Our ref: RPI19/003 – Wilton Coking Coal

RPI19/003 – Wilton Coking Coal

Requirement Notice (*Regional Planning Interests Act, s44*)

Information required for assessment against the SLA Criteria

Figure 1 - Slope Analysis

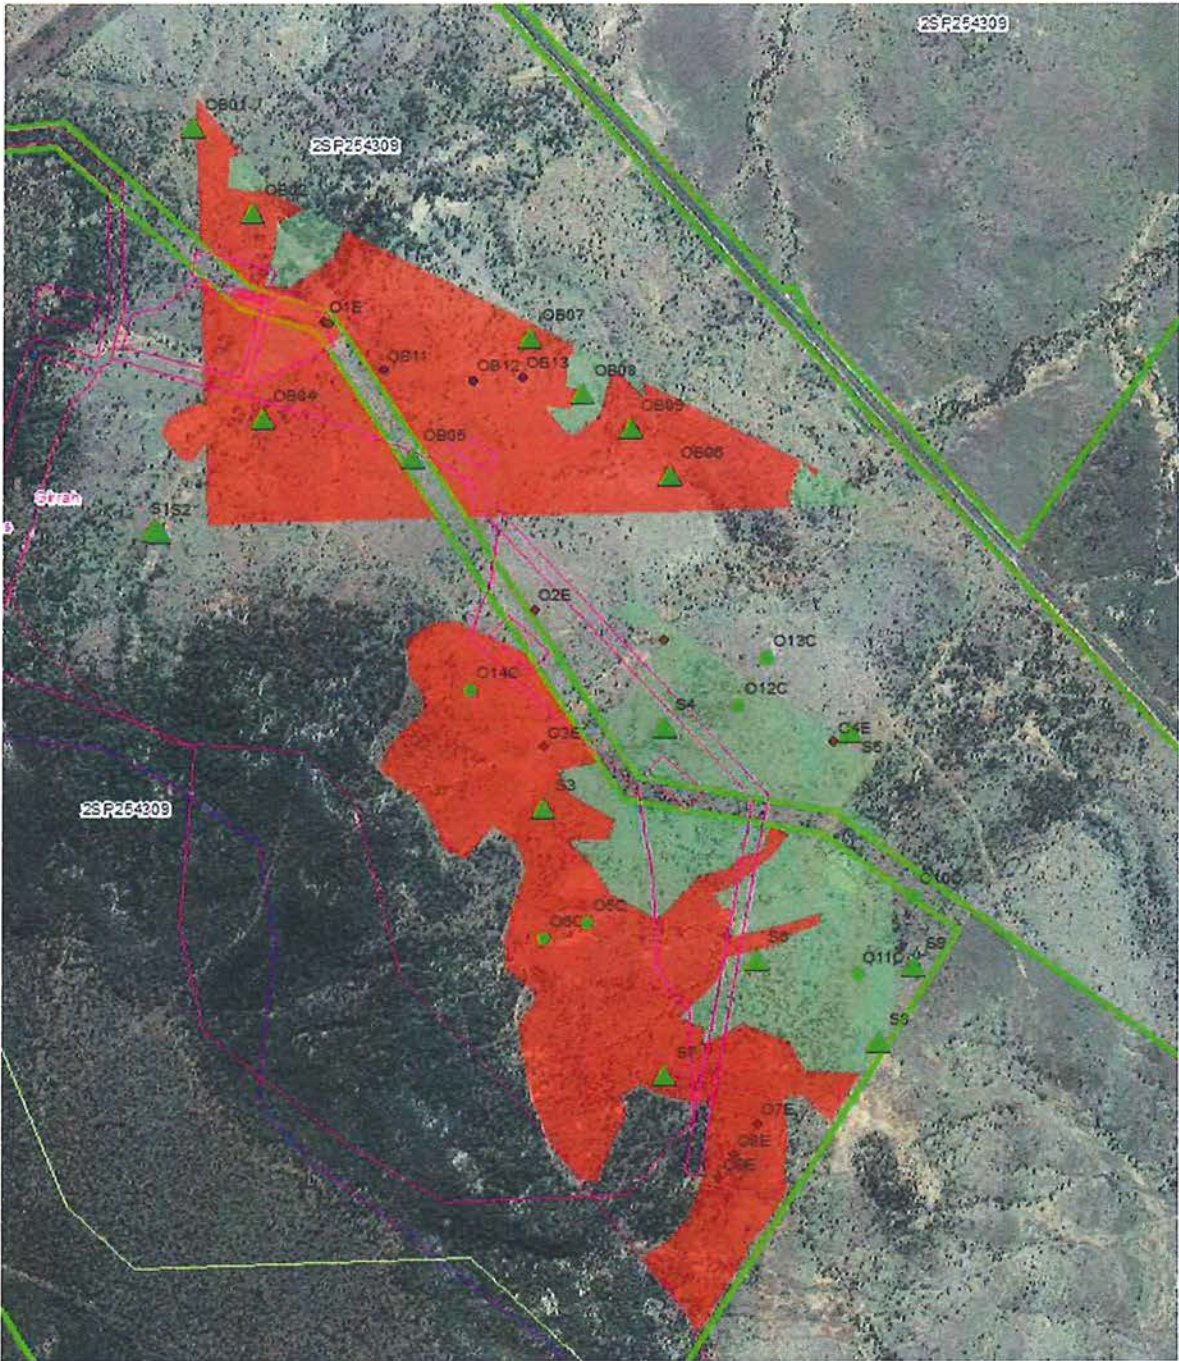
3.	<p>A slope analysis (Figure 1 below) has been undertaken which delineates the areas of slope $\leq 3\%$ (green shading) and areas of slope $> 3\%$ (shaded red). This slope analysis indicates that the location of soil observation/description/analysis sites have not (in the majority) been located in areas where slope is $\leq 3\%$ (i.e. in green shaded areas). For example, only sites OB08, S4, O12C, S6, O11C and S8 (in the image below) are located in currently mapped SCL that is $\leq 3\%$ slope. Many sites are in areas $> 3\%$ slope and sites OB5 and O10C are in areas not impacted by the SCL trigger map.</p> <p>Some of the existing sites are (for example O12C) are lacking the detailed soil description required for adequate assessment. For this site, the soil depth has not been recorded, and there is no analytical data.</p> <p>Please provide a description and analysis of additional sites to better represent the areas of the application with slopes $\leq 3\%$. Refer to section 4 of the RPI Act Statutory Guideline 8/14 to ensure an adequate site density.</p>
